Agenda Item: 6.2
Source: Study Item Rapporteur (BT)
Title: Iu/3 SRNS Relocation
Document for: Decision

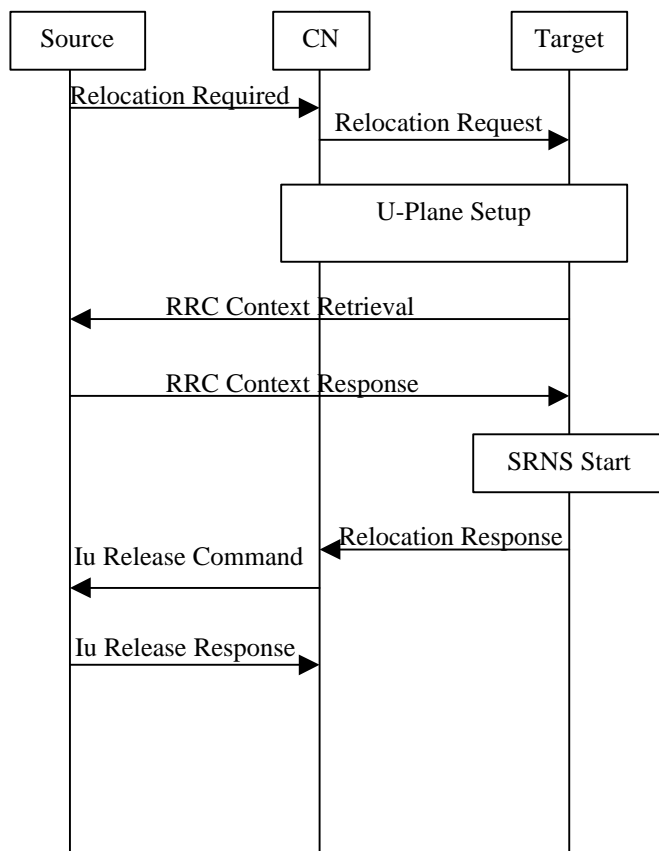
This is the ARIB/TTC proposal. The advantages identified are:

- it keeps more UTRAN specific signalling within UTRAN
- the CN does not need to see the RRC context information
- the RRC context information may be more up to date (depending on what is sent in ETSI Relocation Command)

But it has some problems:

- it is not clear how it can cope with a failure/delay from one CN node, when the other is OK
- in general the failure cases require special treatment, as the success messages cannot be directly replaced with failure messages

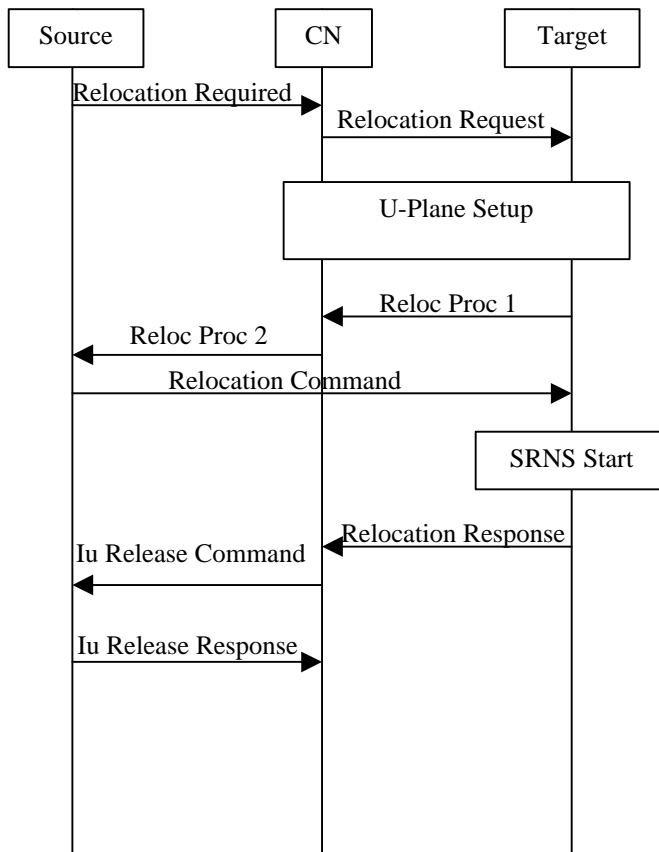
This is the ETSI proposal. The advantages identified are:

- it is very similar to the CN switching handover procedure, and so should fit well with MAP/E
- Source RNS can wait for all Proceeding 2 messages before sending Relocation Command
- it is simpler for the CN to estimate the switch time, as it is involved later in the procedure
- if there is a CN suspend, it can be shorter

But the problems are:

- additional signalling via CN

It has been agreed on the email reflector that the solution using Proceeding 1 and Proceeding 2 messages should be used as the starting point for future development work in RAN WG3.
